Red-line Version of Replacement Pages

CROW BUTTE RESOURCES, INC.

Technical Report North Trend Expansion Area

**FIGURE 6.1-1
Restoration Process Flow Diagram**

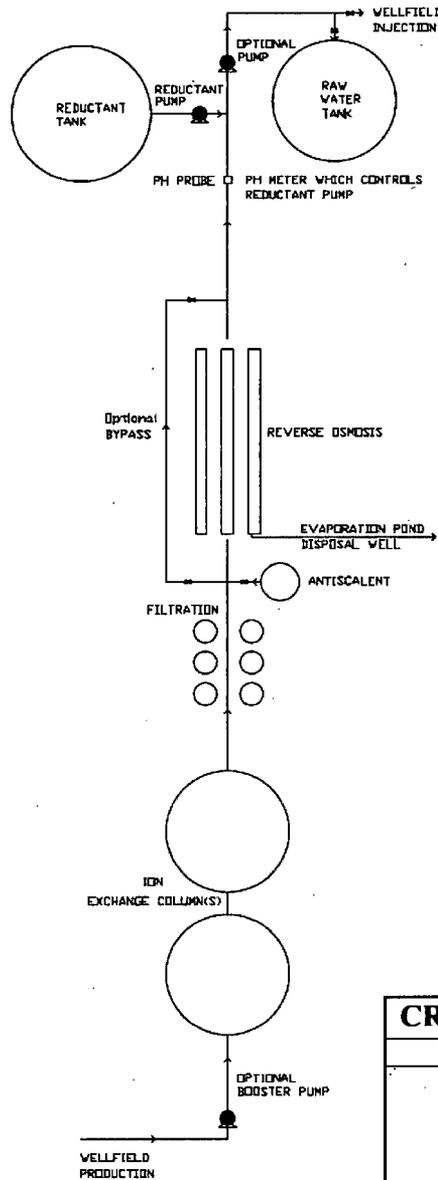
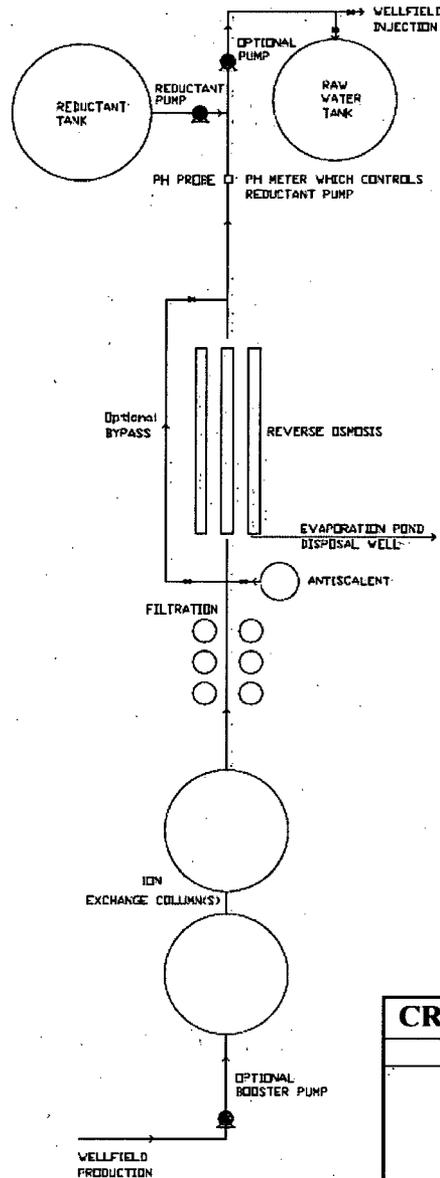
Following the groundwater sweep step, water will be pumped from production wells to treatment equipment and then re-injected into the wellfield. Ion exchange (IX), reverse osmosis (RO), and/or Electro Dialysis Reversal (EDR) treatment equipment is generally used during this stage as shown on the generalized restoration flow sheet on Figure 6.1-1.

Figure 7.3-1 Human Exposure Pathways for Known and Potential Sources from the North Trend Expansion Area

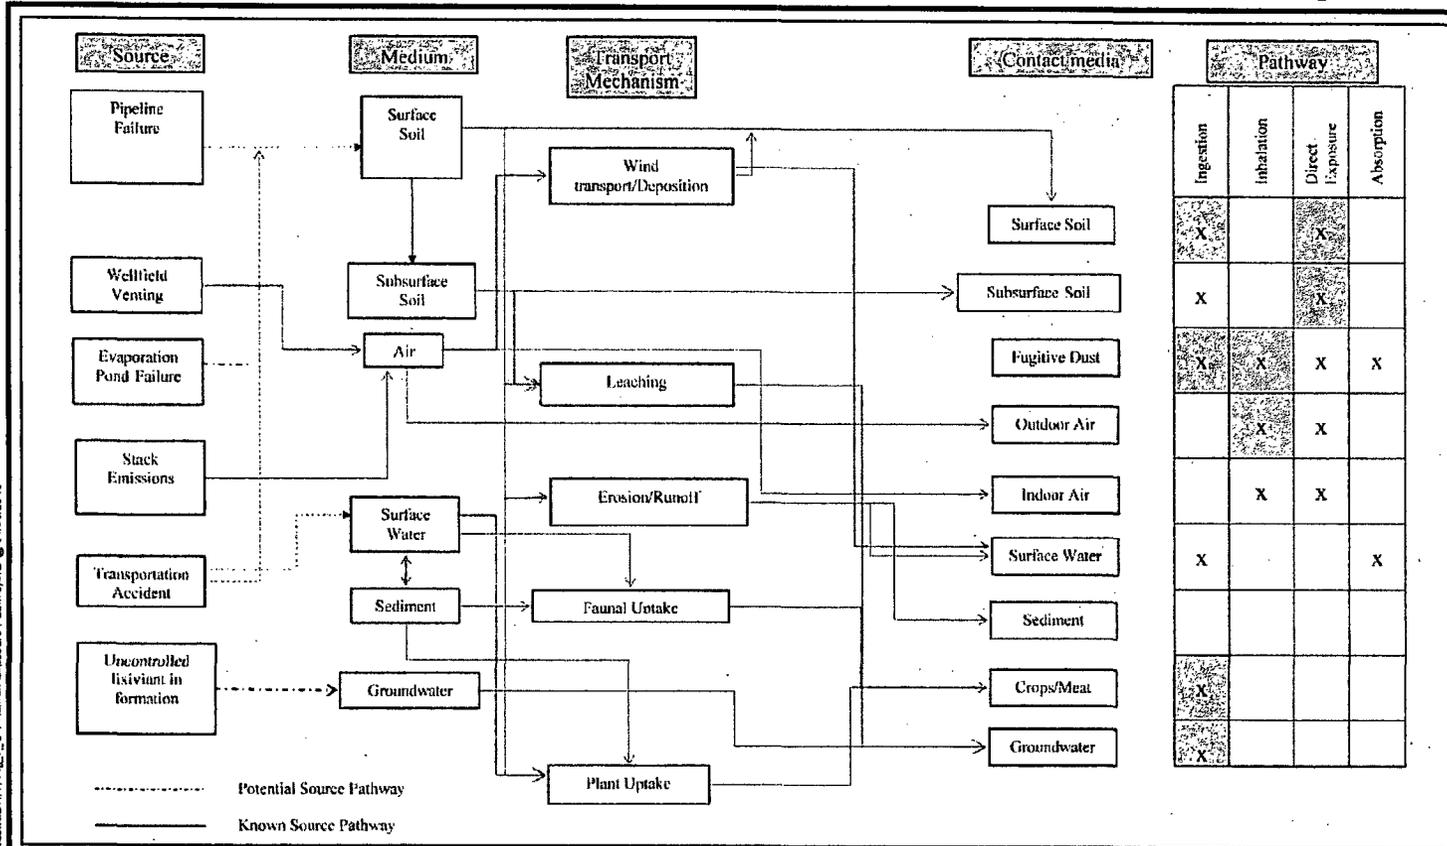
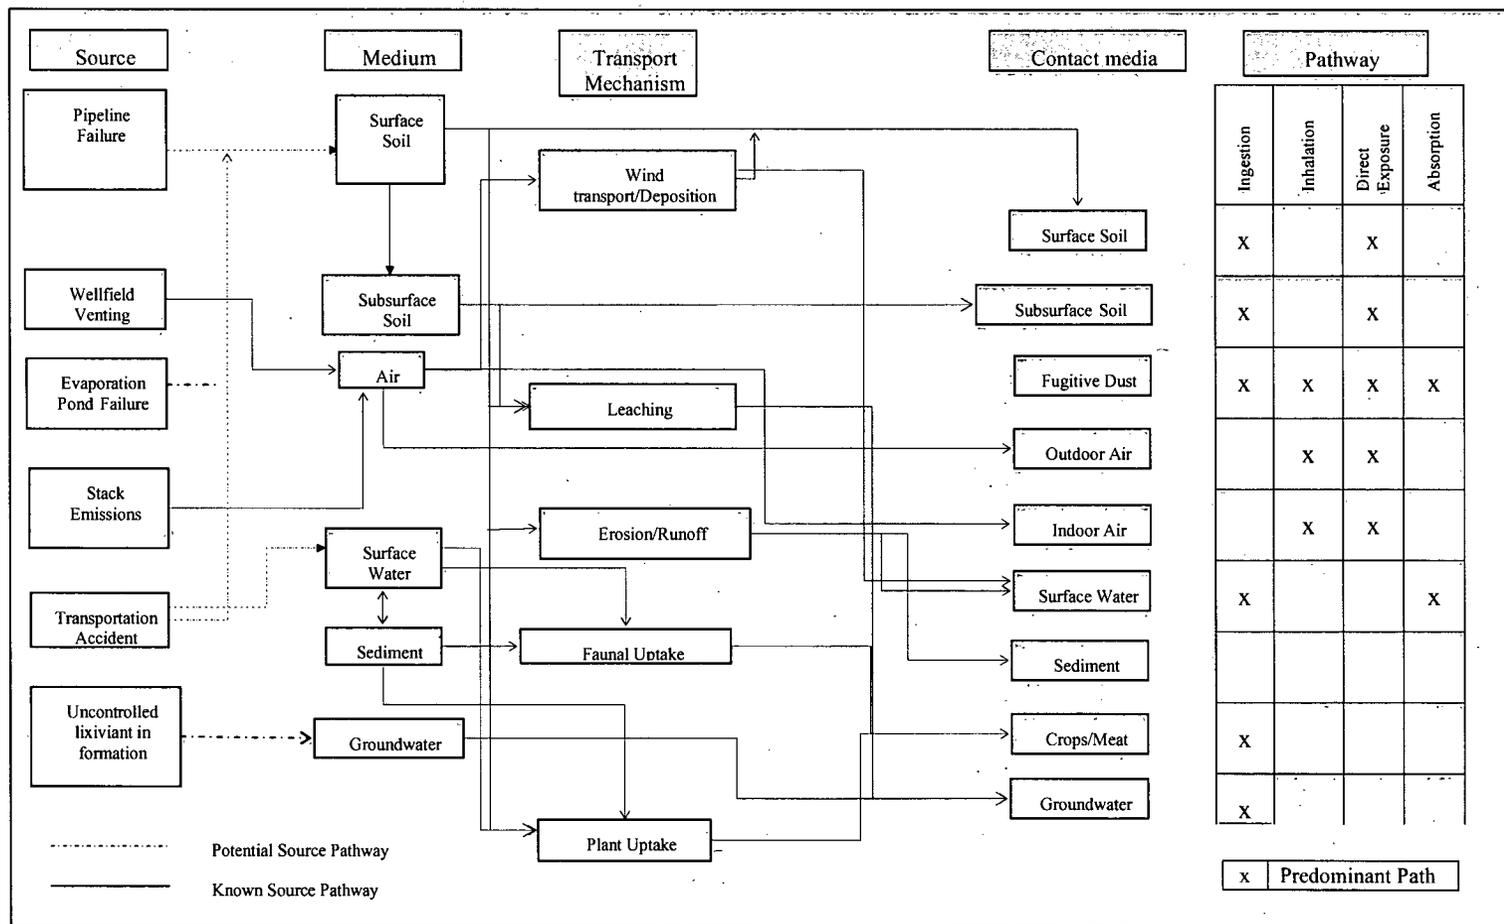
The proposed North Trend Satellite Facility is an in-situ leach uranium facility. The only source of planned radioactive emissions from the satellite is radon gas, which is dissolved in the leaching solution. Radon gas may be released as the solution is brought to the surface and processed in the satellite facility. Unplanned emissions from the site are possible as a result of accidents and engineered structure failure but are not addressed in the MILDOS-Area modeling. A human exposure pathway diagram addressing planned and unplanned radiological emissions is presented in Figure 7.3-1
